Keithley Instruments
28775 Aurora Road
Cleveland, Ohio 44139
1-800-833-9200
tek.com/keithley

Model 2450 Interactive SourceMeter® Instrument, 2450-NFP, 2450-RACK, 2450-NFP-RACK

VERSION 1.7.16 RELEASE

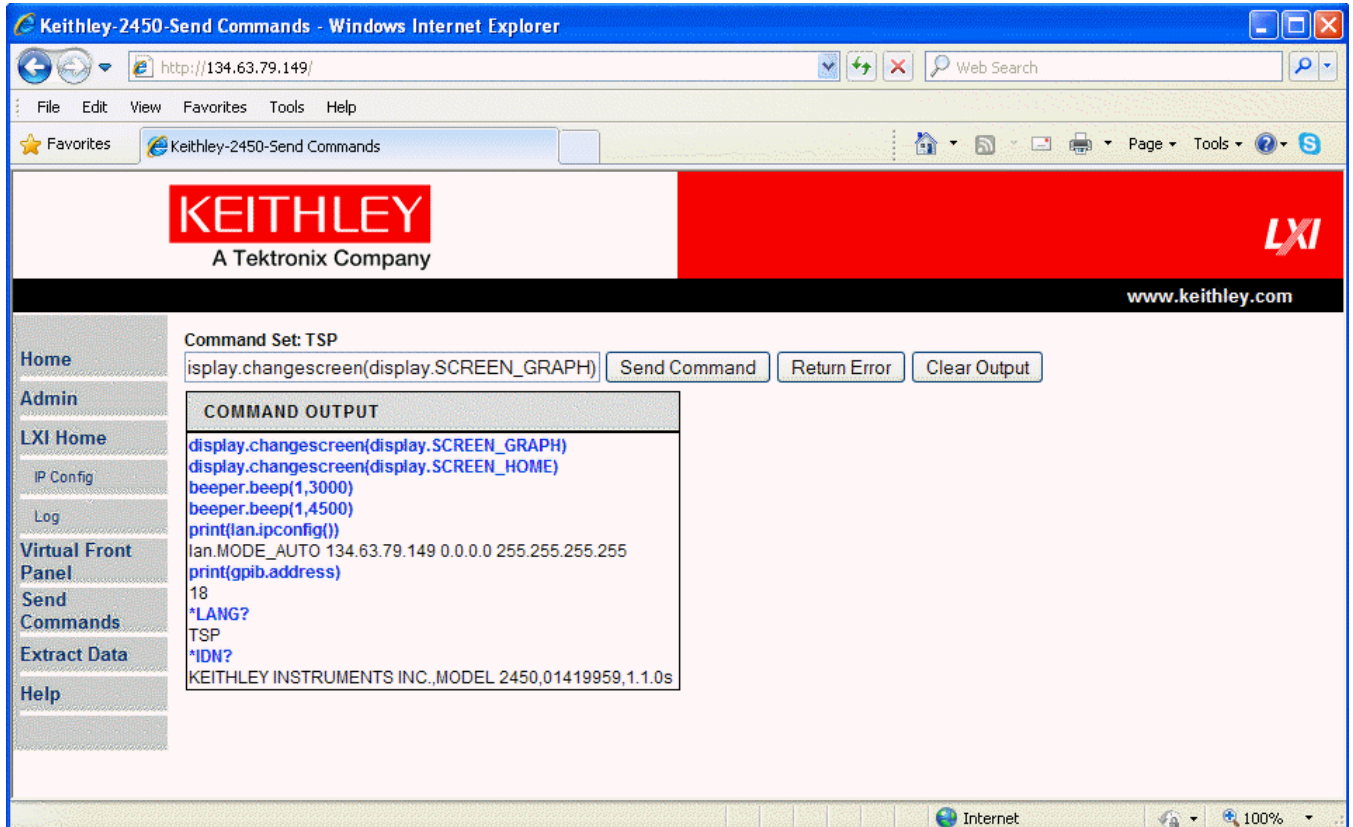
The behavior of the *LANG? command on the 2450 has been changed as follows.

Sending the query *LANG? over a non-controlling interface will no longer change the interface control of the unit. For example, if the unit is under local control, then sending the *LANG? over Telnet, USB, or GPIB will leave the unit under local control. This was done in order for KickStart (or any other remote control software) to query connected/accessible instruments without resetting them or changing or disturbing the current trigger model.

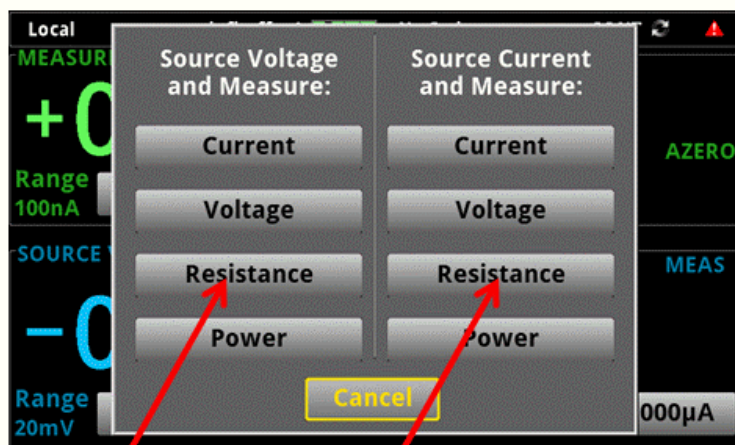
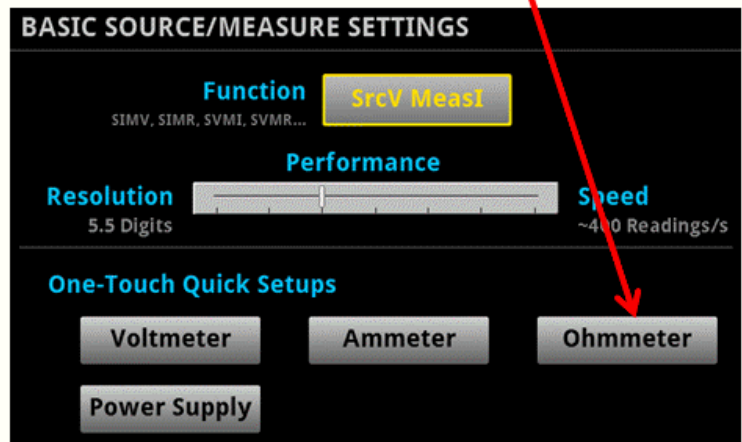
- g. New SCPI Command Usage:
 - i. "Manual Ohms" (see definition above)
 - SOURce:FUNC VOLTage
 - [SENSe[1]]:FUNC "CURRent"
 - [SENSe[1]]:CURRent:UNIT OHMOR
 - SOURce:FUNC CURRent
 - [SENSe[1]]:FUNC "VOLTage"
 - [SENSe[1]]:VOLTage:UNIT OHM
 - ii. "Auto Ohms" (see definition above)
 - [SENSe[1]]:FUNC "RESistance"
- h. Front panel user interface setting of Manual vs. Auto Ohms measurements
<see the following figure for details>

Both exhibit "Manual" Ohms behavior (works just like Power by setting units to Ohms and going to SVMI or SIMV)

Exhibits "Auto" Ohms behavior
